REQUEST

Current Zoning: MUDD-O (mixed use development, optional)
Proposed Zoning: MUDD-O SPA (mixed use development, optional, site plan amendment)

Approximately 0.82 acres located on the south side of Montford Drive, east of Park Road
(Council District 6 - Bokhari)

The petition proposes a site plan amendment to a previously approved site plan allowing redevelopment of an infill parcel for a mixed use commercial building in the Montford Park area south of the Park Road Shopping Center.

• **Proposed Request Details**

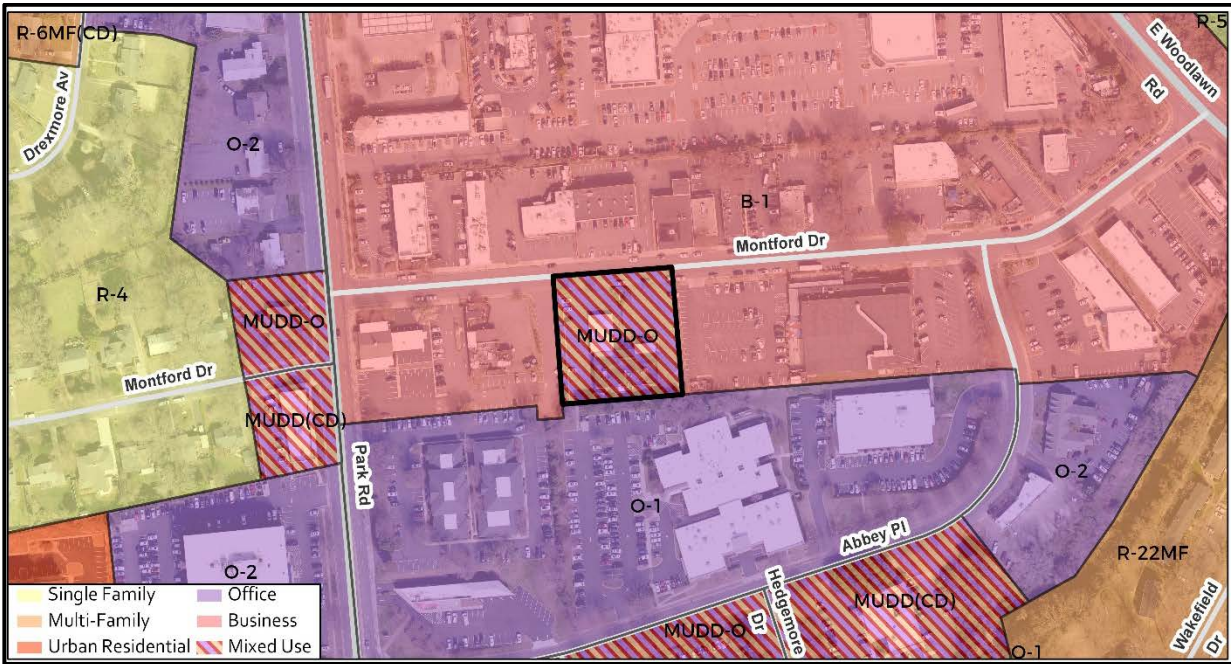
- Replaces the proposed surface parking (shown on the previously approved site plan) to the rear of the building with a parking structure at the rear of the building. Specifies the parking structure will not exceed the height of the building.
- Increases the maximum height of the building from 60 feet to 85 feet.
- Removes the 27,500-square foot maximum building square footage cap. The proposed building would be located within the building envelope depicted on the site plan.
- Removes a previously approved optional provision allowing parking to extend past the building façade on the unnamed side street.
- **Provides bump out on Montford Drive at the unnamed street.**

1. ~~Amend the sidewalk and planting strip shown along the unnamed side street to match what is stated in Note 5.a. specifying a 16 foot setback with an eight foot planting strip, with hardscape sections connecting the curb to the sidewalk a minimum eight foot sidewalk which may extend to the building façade.~~ Addressed.
2. ~~Amend the label for the setback on the unnamed side street to specify if it is existing or future back of curb.~~ Addressed, the existing curb line is specified because the curb is in the future location.

3. Revise the site plan and conditional notes to stub across access drive to the adjacent parcel (PID 17514501) per Transportation Policy T-4 in the *Park Woodlawn Area Plan*. Staff rescinded this request. The petitioner has stated that cross access would impede the proposed parking structure and that the neighboring property does not support cross access. The prior rezoning did not include cross access.

4. Revise the site plan to create bump outs for on-street parking on Montford Drive. Addressed; the petitioner has committed to provide a bump out on Montford Drive at the unnamed street. The petitioner has stated that there is not infrastructure at this location to deal with potential water runoff issues from additional bump outs along Montford. The petitioner will further discuss these matters at permitting should the infrastructure exist at that time. During the prior rezoning similar stormwater issues along Montford Road were discussed. The proposed streetscaping is the same as approved by Council with staff support.
